Re: Responses to Recommendations in Final Coal Combustion Waste Impoundment Round 7 - Dam Assessment Report for Riverside Generating Station

Riverside Generating Station Recommendations

1.2.1 Recommendations Regarding the Structural Stability

Re: Geotechnical Report Addendum No. 2
Revised Global Stability Analyses
South Ash Containment Pond Embankments
Riverside Generating Station
Bettendorf, Iowa
Terracon Project No. 07105081/02105081G

Geogrid placed at elevation 566’ from about Station 6+00 to about Station 8+95
Direction Looking: South Date: 07/27/2011

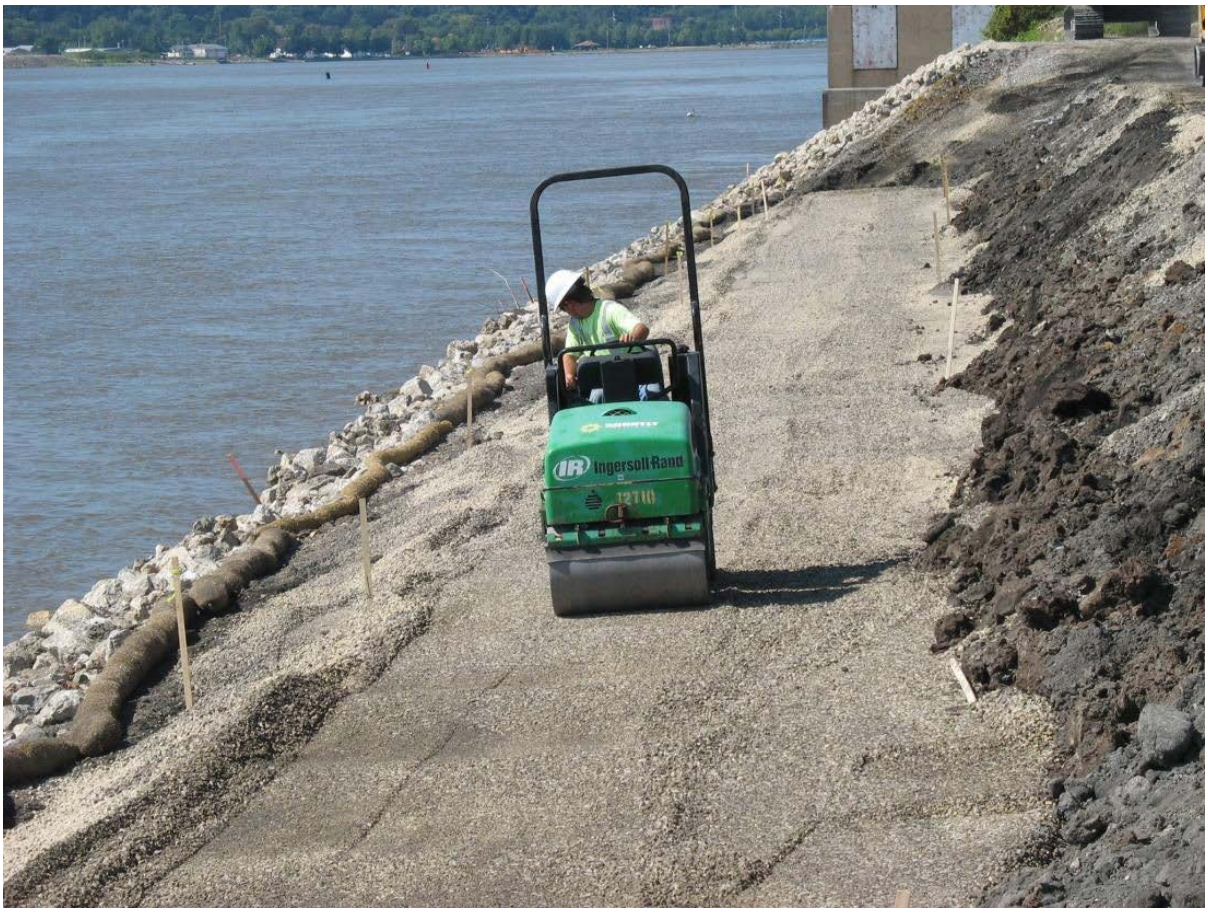
EPA Comment: Corrective measures should be implemented to improve the stability of the South Ash Pond in order to meet required safety standards for dams. MEC is aware of the deficiency and is preparing and intends to implement plans to address this concern. USEPA has requested that MEC document their plans for the improvement.

MEC Response: A project was initiated June 17, 2011, to improve the slope stability factor of the South Ash Pond such that it meets or exceeds the required factor of safety of 1.5. MidAmerican Energy Company ("MidAmerican") retained a qualified contractor to install dewatering wells and inclinometers, excavate the existing rip rap armor components, excavate the existing levee embankment material down to an elevation of 564 Mean Sea Level, and replace the embankment in compacted layers utilizing suitable materials and geogrid reinforcement. The majority of the project has already been completed and it is on schedule for final completion in September 2011.

The following photographs provide visual documentation of the status of the South Ash Pond levee improvement project.
